IREDELL COUNTY HEALTH DEPARTMENT
JANE MURRAY, RN BSN MS
HEALTH DIRECTOR

Shepherd's Bluff, Phase 4, Lot 50
4659-56-8901

Re: Application for improvement permit for Tran Cruz property site 237 Shepherd's Bluff Dr. Mooresville Health Department file number 216141

Based on the criteria set out in Title 15A, Subchapter 18A, of the North Carolina Administrative Code, Rule .1940 through .1948, the evaluation indicated that the site is UNSUITABLE for a sanitary system of sewage treatment and disposal. Therefore, we must deny your request for an improvement permit. A copy of the site evaluation is enclosed. The site is unsuitable based on the following:

SOIL/SITE EVALUATION

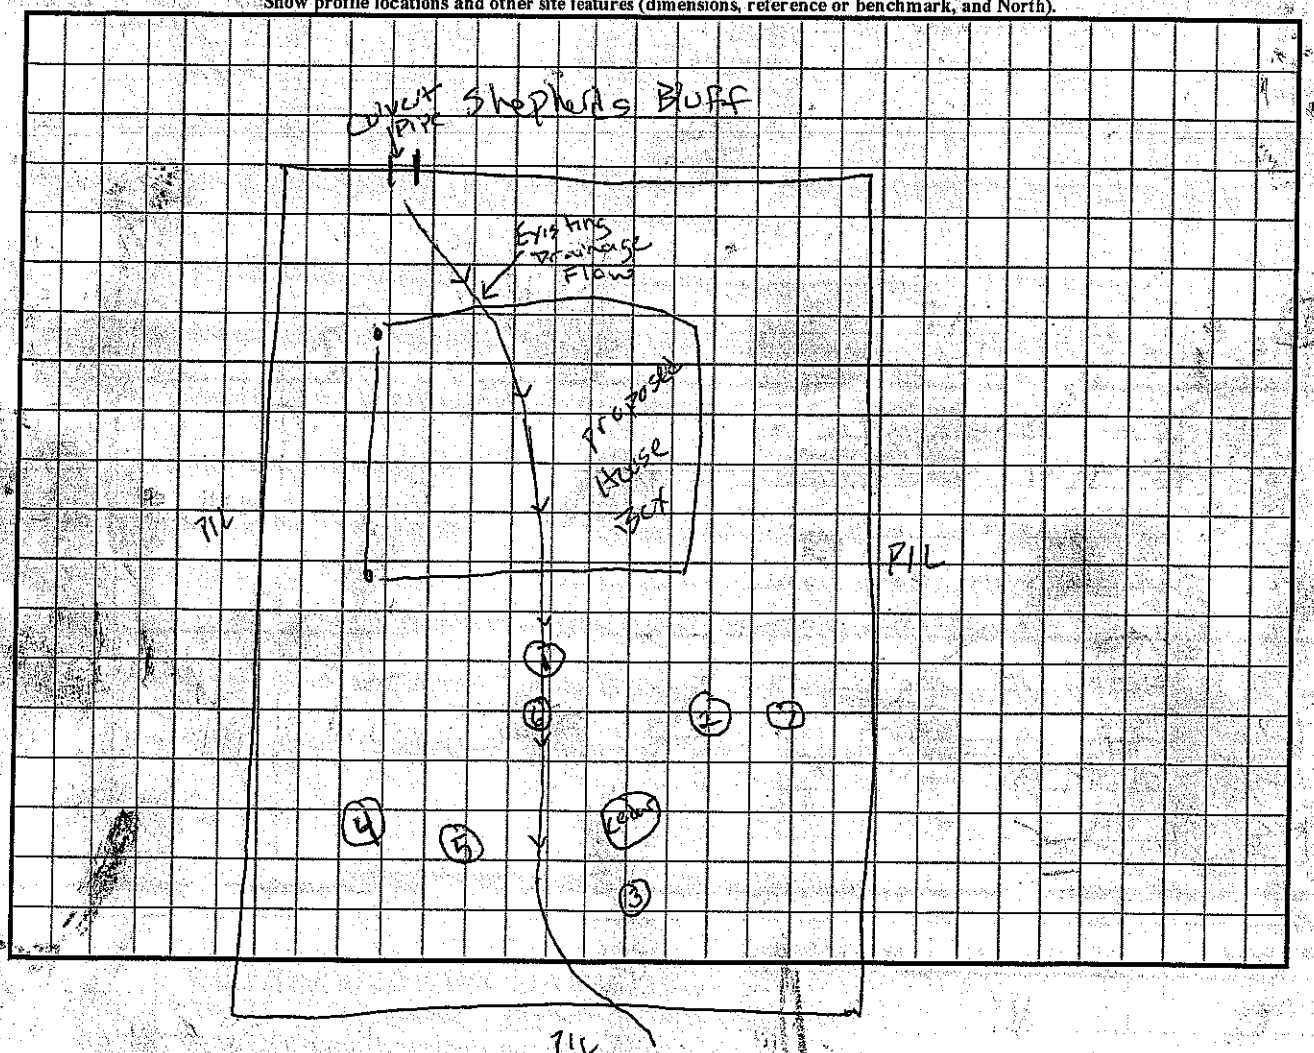
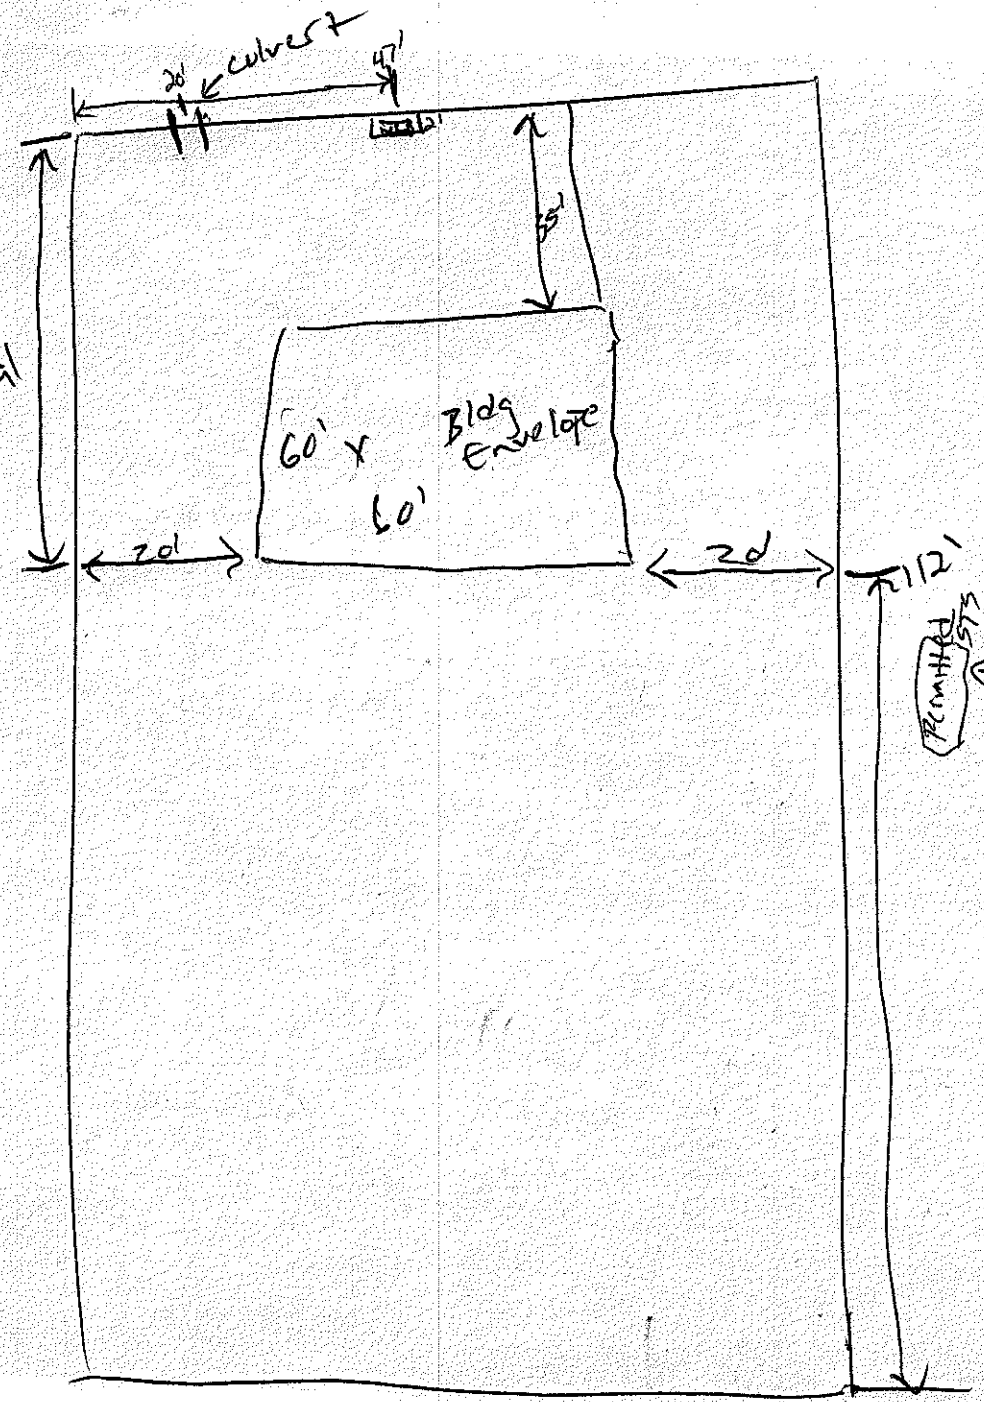
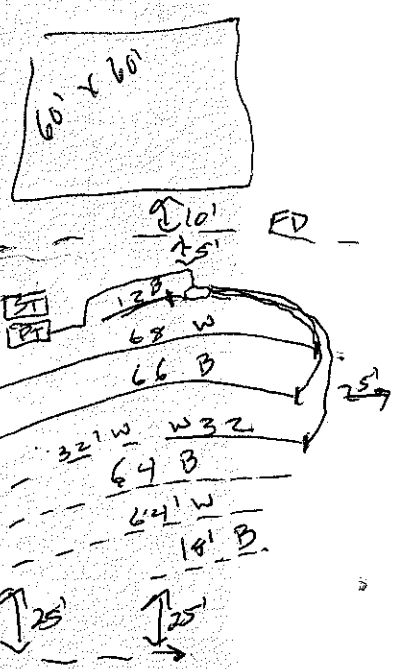
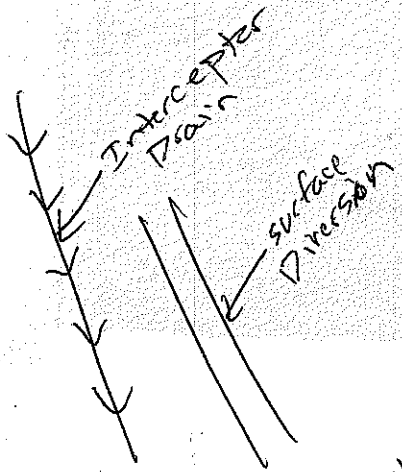
__X__ Unsuitable soil topography and/or landscape position (Rule .1940)
_____ Unsuitable soil characteristics (structure or clay mineralogy) (Rule .1941)
_____ Unsuitable soil wetness condition (Rule .1942)
_____ Unsuitable soil depth (Rule .1943)
_____ Presence of restrictive horizon (Rule .1944)
__X__ Insufficient space for septic system and repair area (Rule .1945)
__X__ Unsuitable for meeting required setbacks (Rule .1950)
_____ Other (Rule .1946) _____

well must be 100'

5' Deep Interceptor Drain

*No Cutting

* - All Gutter & Foundation Drains Outlet in Surface diversion ditch
